Project/Client:		Project No:	
South Yorkshire Police		IABR13003900	
Barnsley Custody Suite		112	
		Rev:

Drawn:		Scale:	
Proposed Roof plan		1:100 @A1

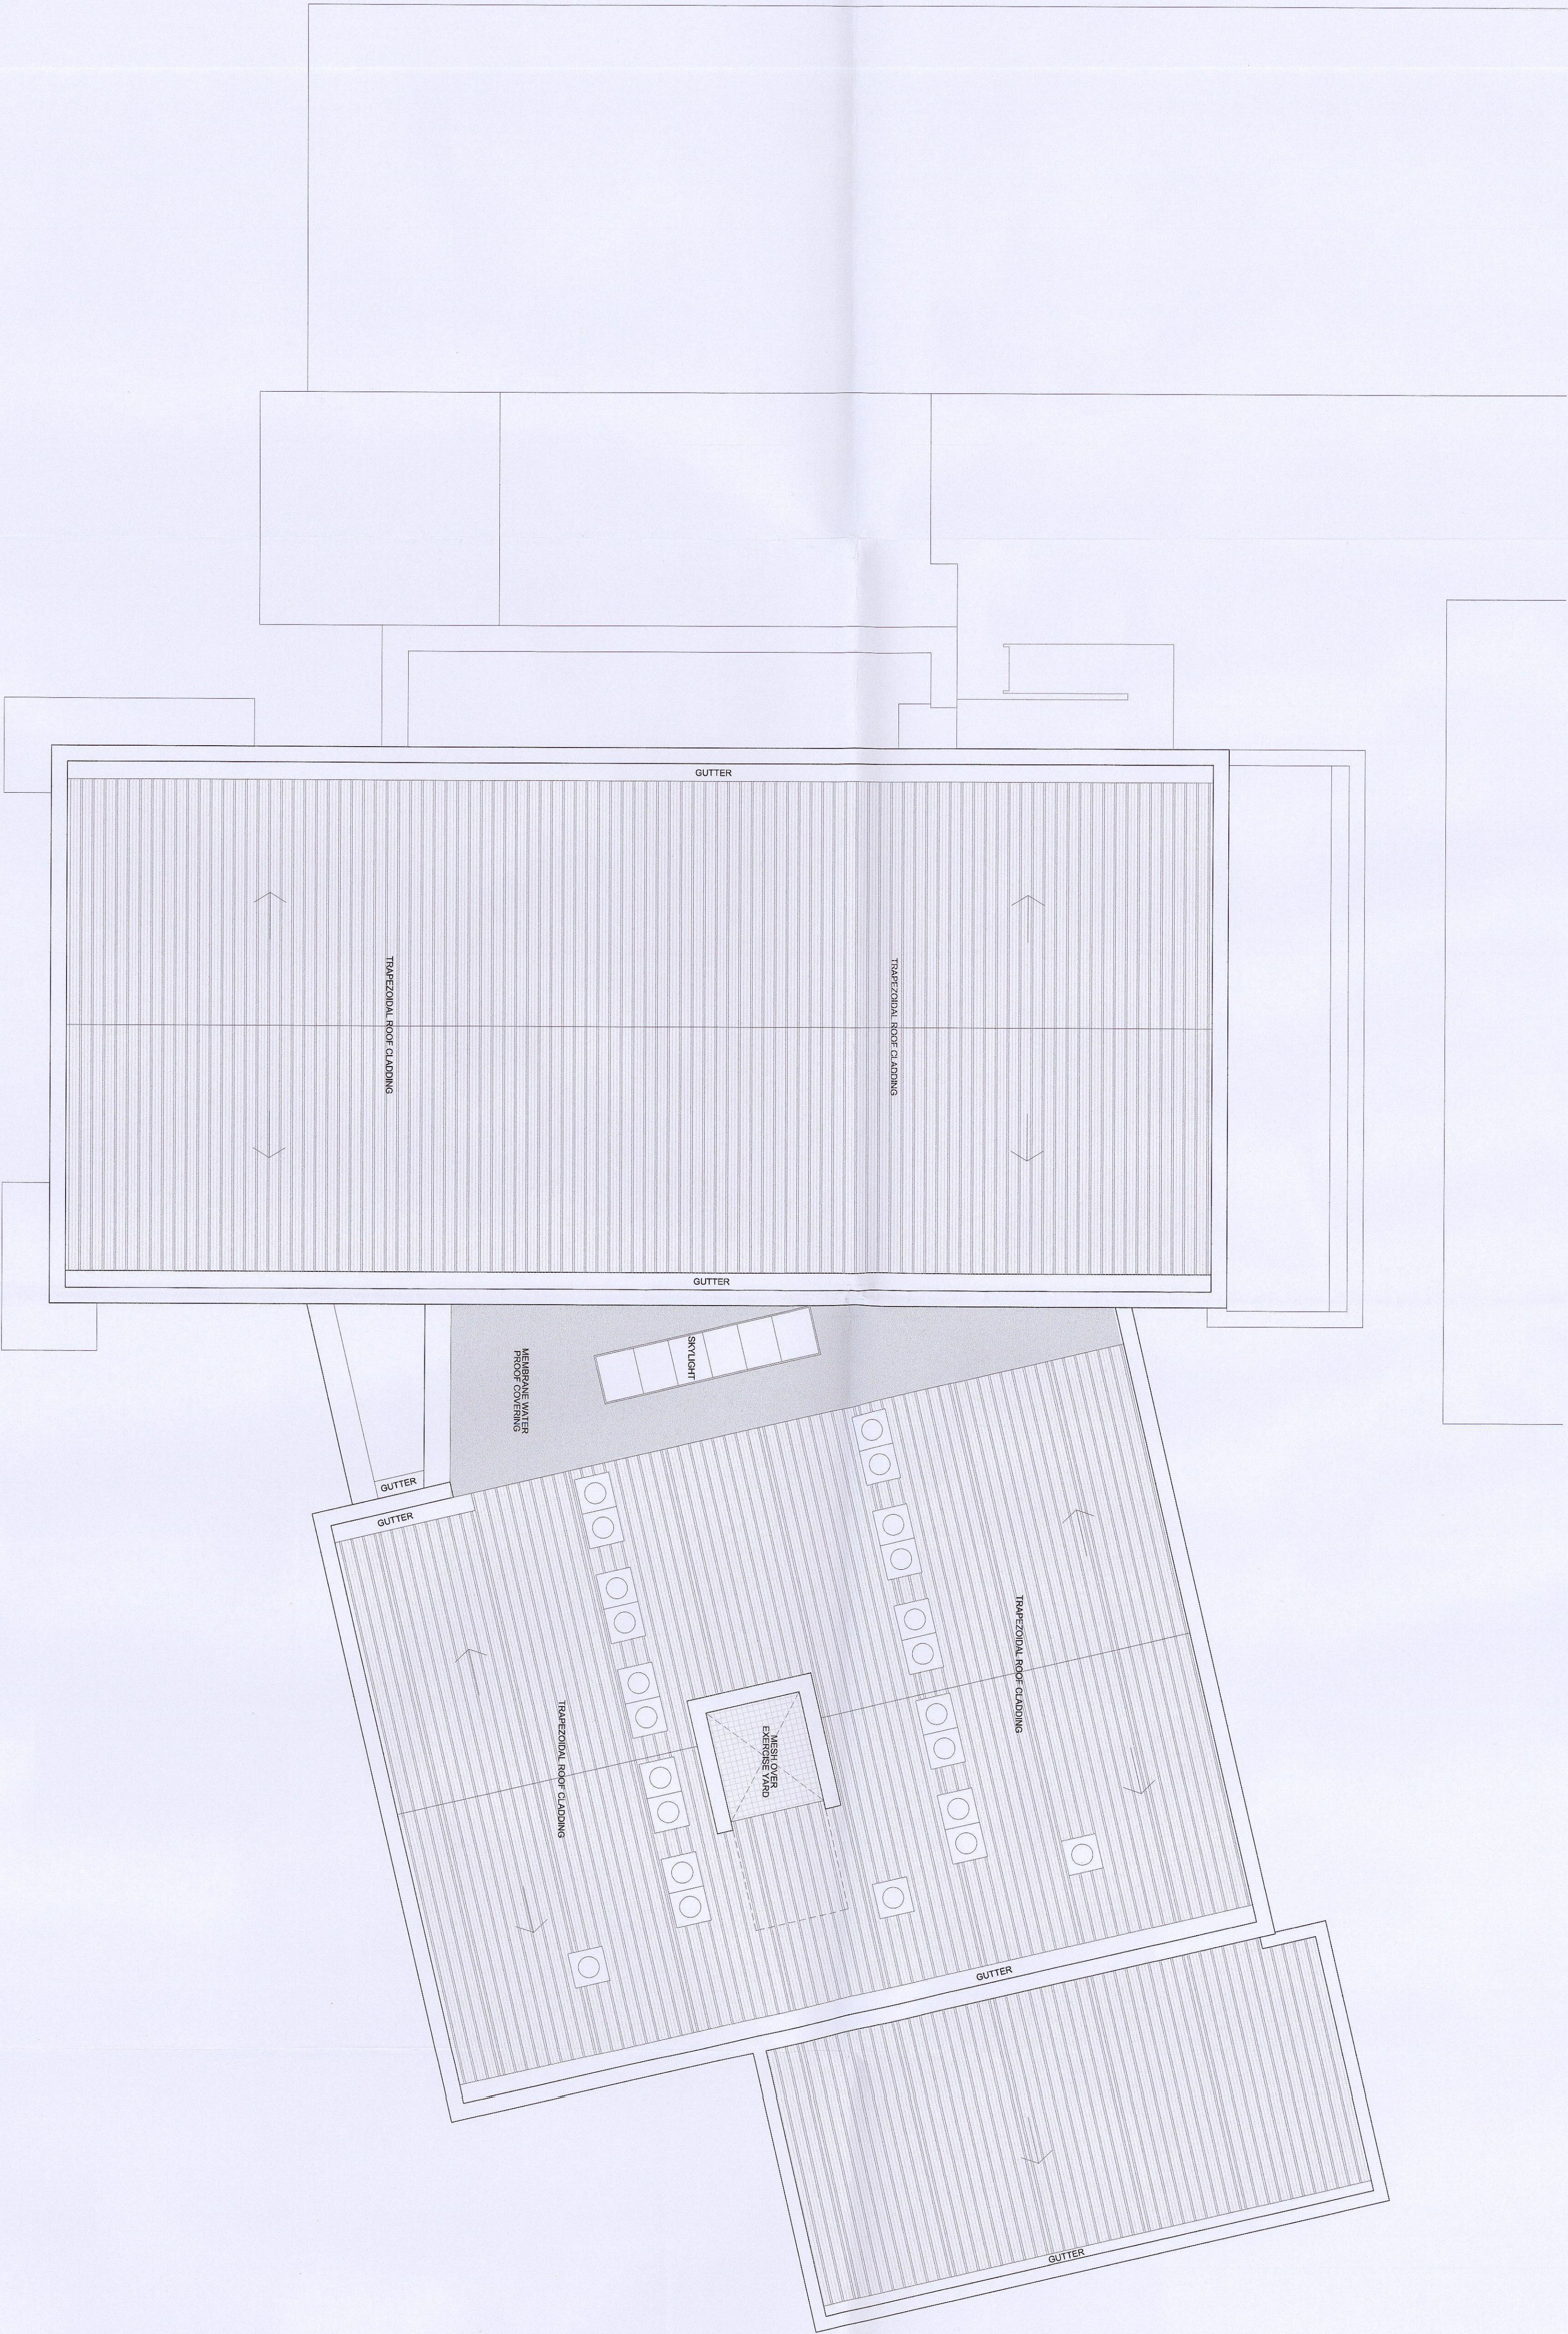
C 04.03.14 Additional gutter indicated at angle. Planning issue.				VG	SC
B 01.03.14 Rooflight revised.				KAM	SC
A 19.03.14 Revised to reflect MDC comments.				KAM	SC
Rev.	Date	Drawn	Checked	Drawn	Checked
